APPLICATION FOR PERMISSION UNDER SECTION 16 OF THE TOWN PLANNING ORDINANCE (CAP. 131)

(a) Proposed use(s)/development 擬議用途/發展	Proposed Temporary Open Storage of Construction Materials and Vehicles and Associated Filling of Land for a Period of 3 Years (Please illustrate the details of the proposal on a layout plan) (請用平面圖說明擬議詳情)

(S.16 Planning Application No. A/YL-SK/426)

Departmental Comments		Applicant's Responses
1. Comments of the District Planning Officer/Fanling, Sheung Shui and Yuen Long East, Planning Department (DPO/FSYLE, PlanD) (Contact Person: Mr. David CHENG; Tel:)

DWG. TITLE
FSI PROPOSAL

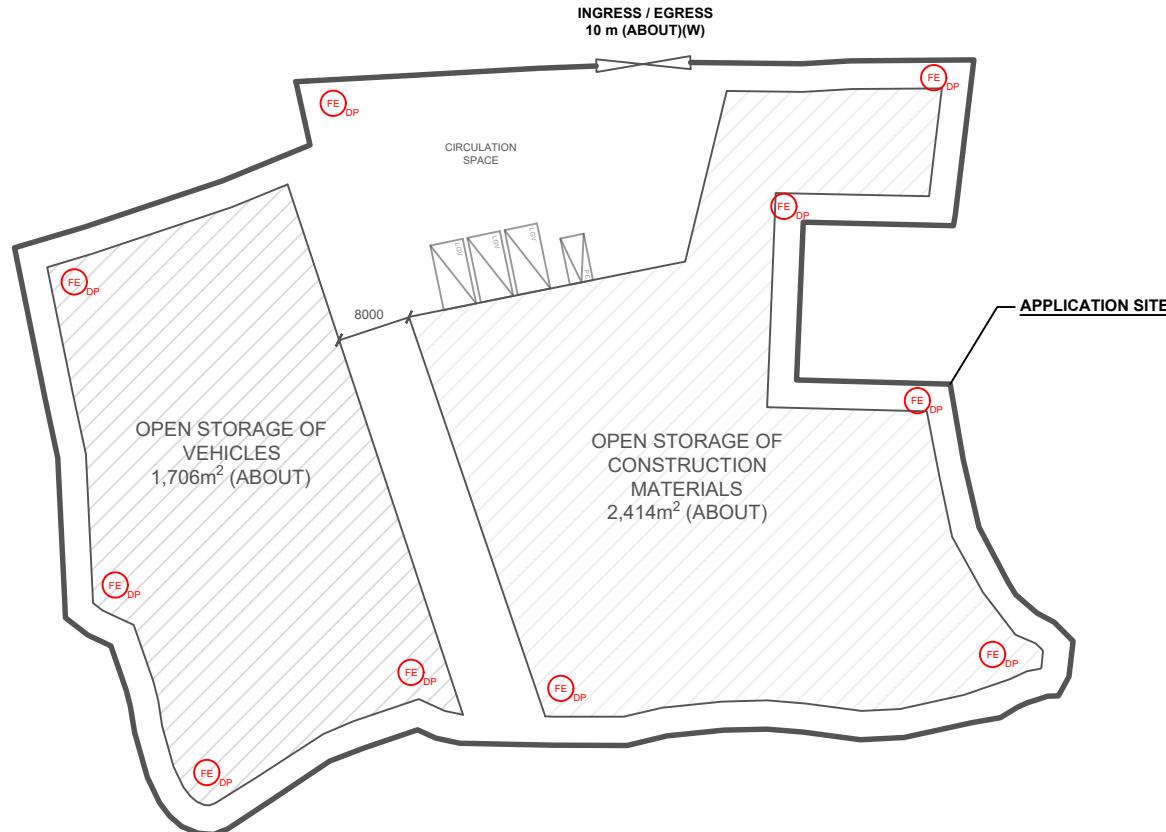
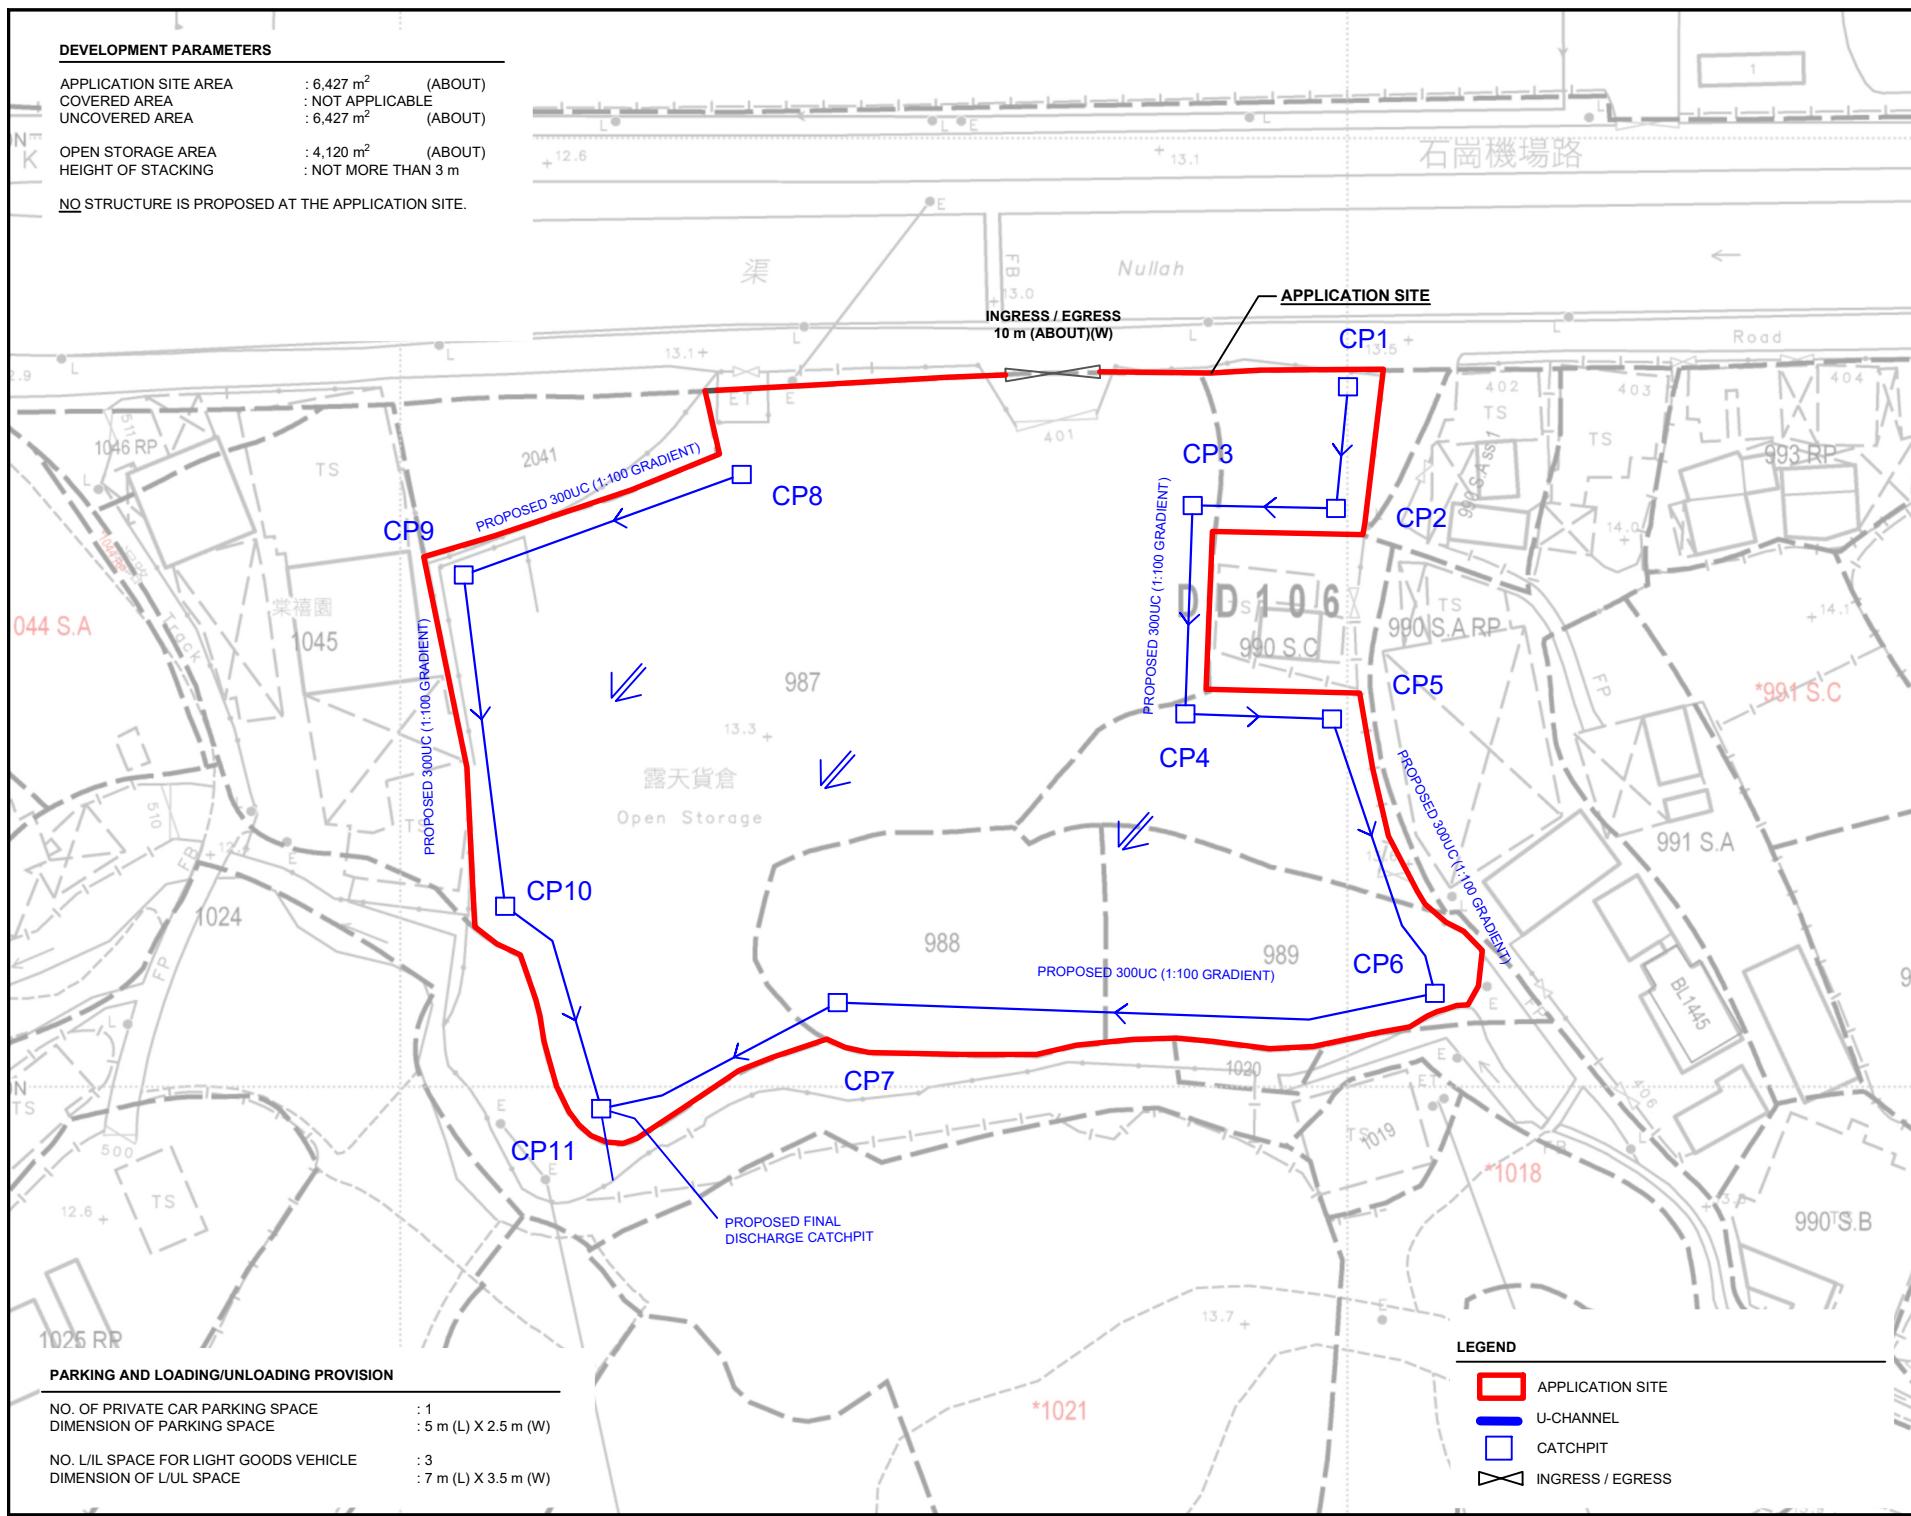
(a)	According to the applicant's submission, the subject site (the Site) has an area of about 6,427m ² and has already been hard-paved. Open Storage of construction materials and vehicles (80 private cars and light goods vehicles) will be involved. To the north of the Site is a streamcourse. To the immediate south of the Site is an area subject to earlier application No. A/YL-SK/371 for temporary open storage, with a site area of about 7.8ha (filling of land for 100% site area), which was approved with conditions by the Rural and New Town Planning Committee of the Town Planning Board in 2025. The Site is surrounded to the east and west by residential structures and vegetation. Considering the site context and scale of the proposed use, drainage and fire service installations proposals shall be submitted to the relevant departments for review.	Noted. The fire service installations and drainage proposals are provided by the applicant in support of the application (Annexes I and II).

FIGURE NUMBER
FIGURE 3

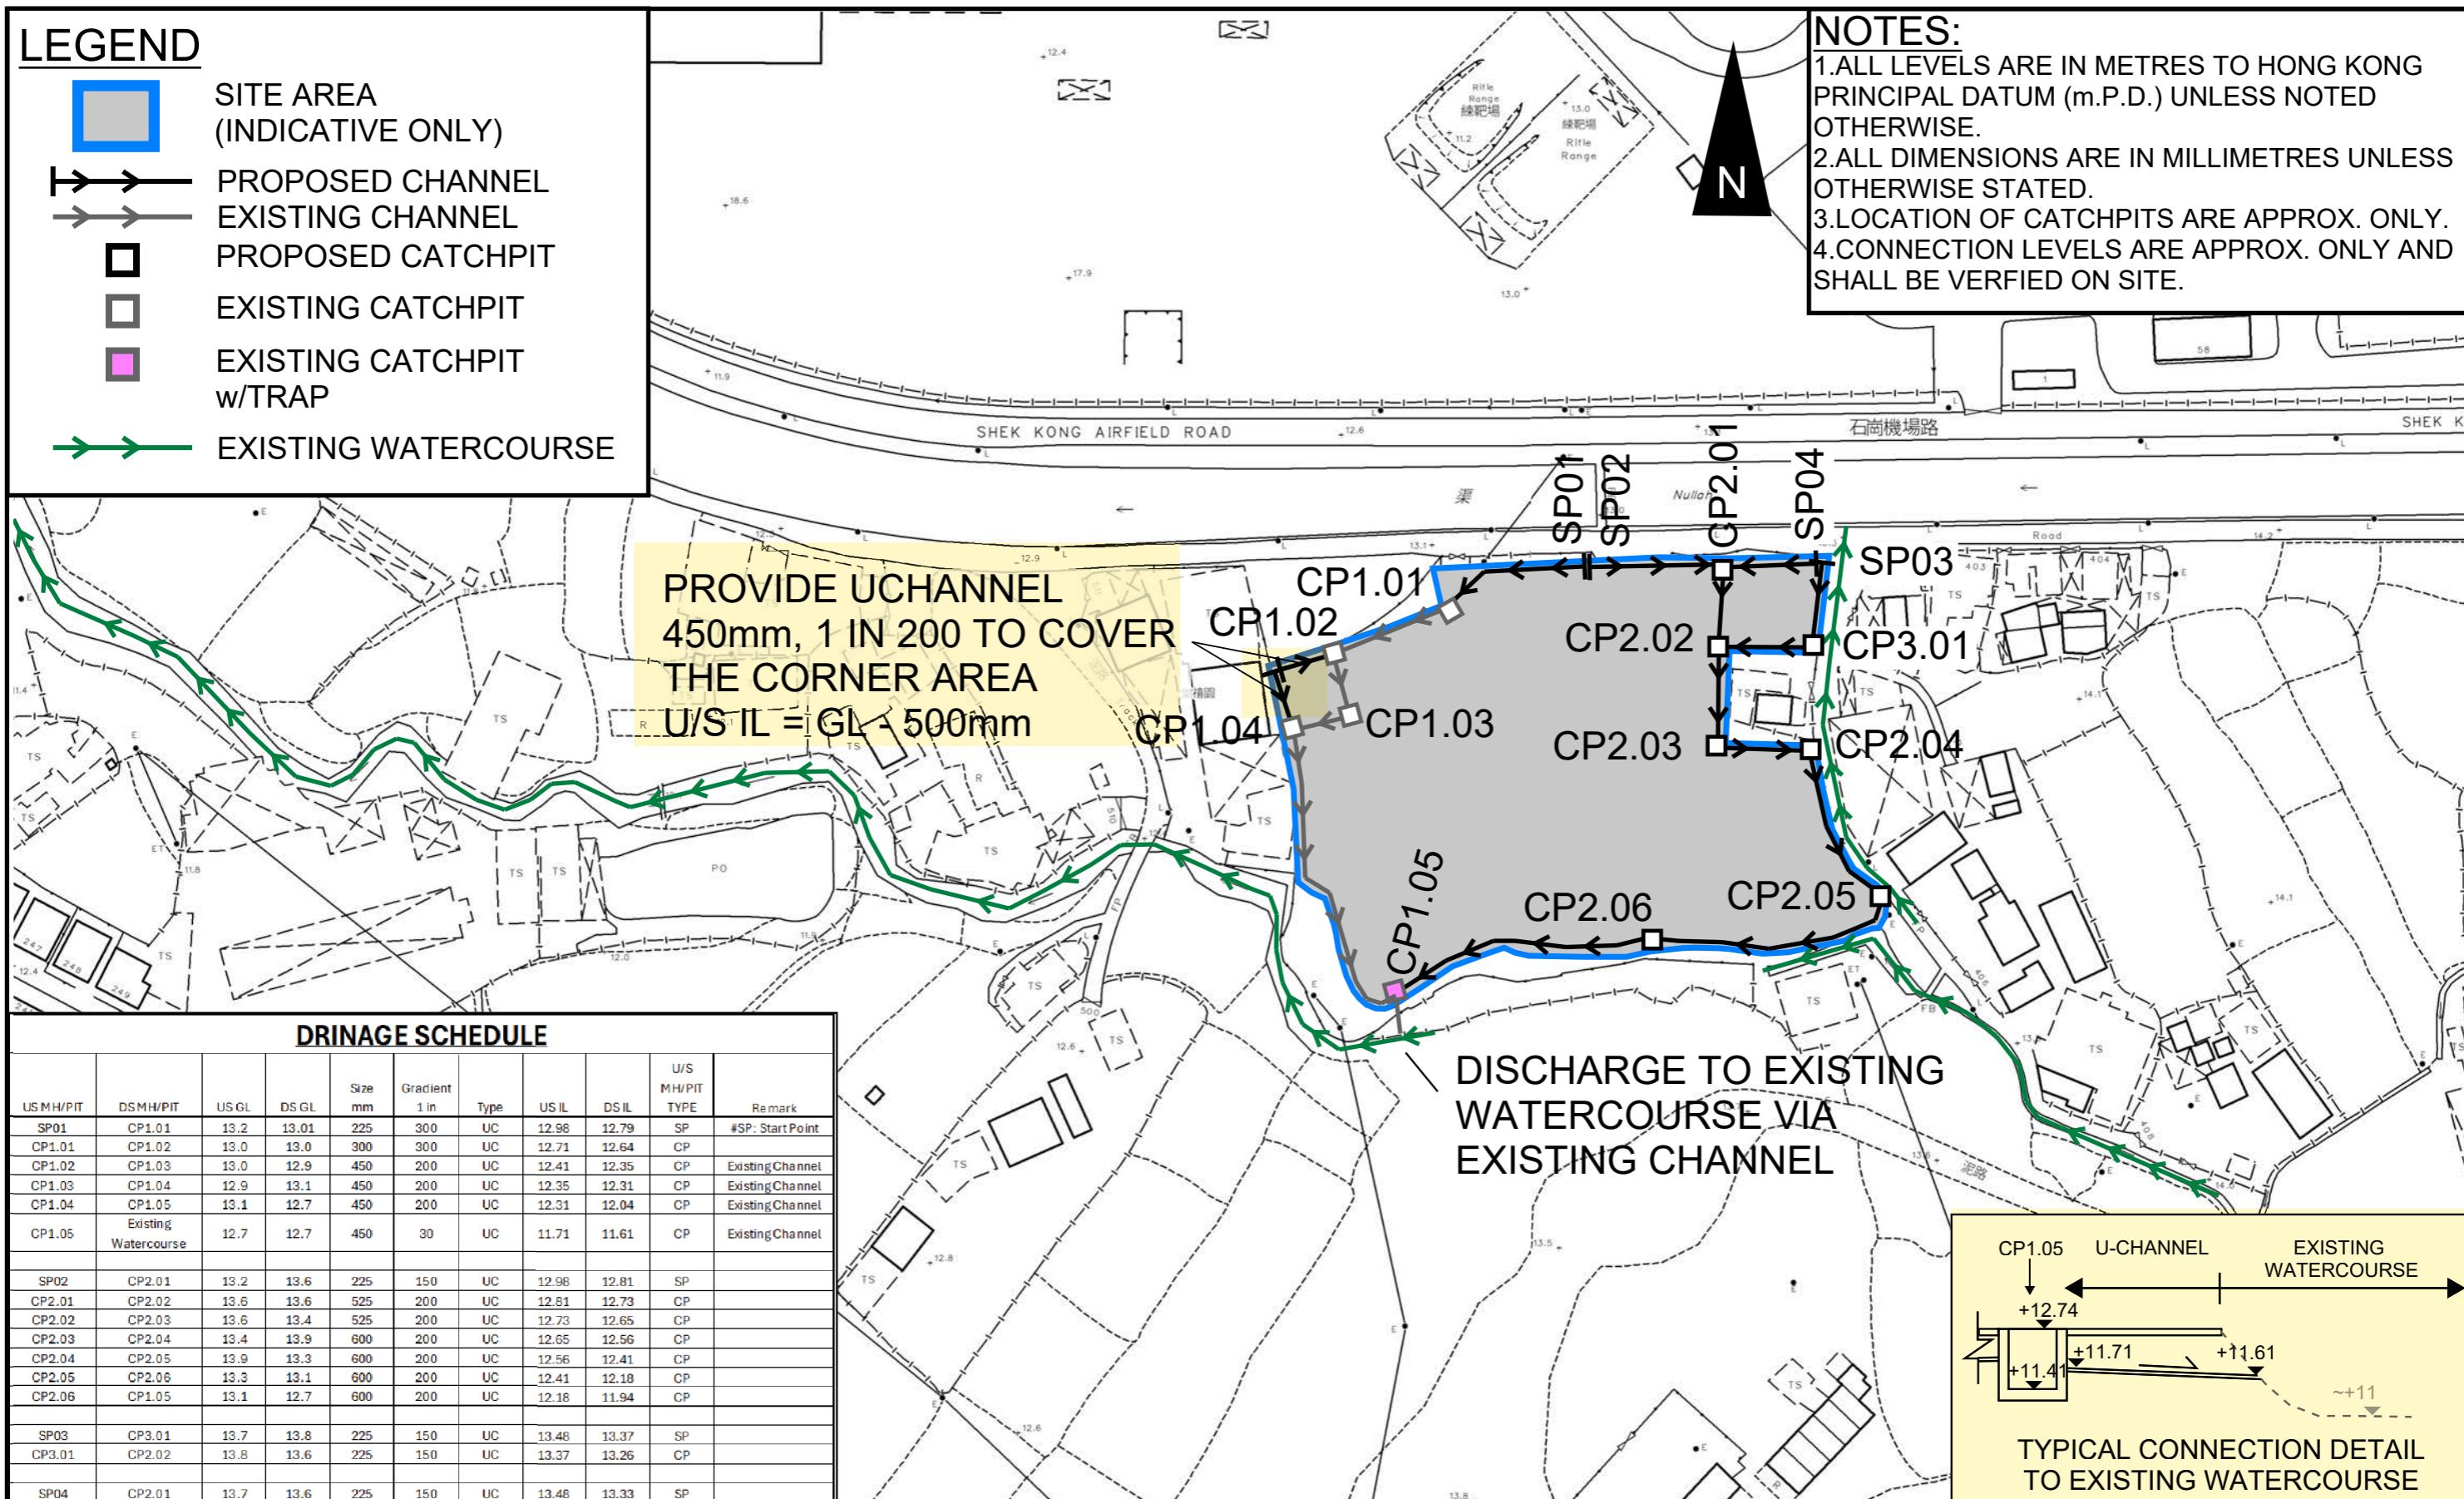
(c)	<p>Please provide channels cover the area in the northwestern corner of the application site.</p>
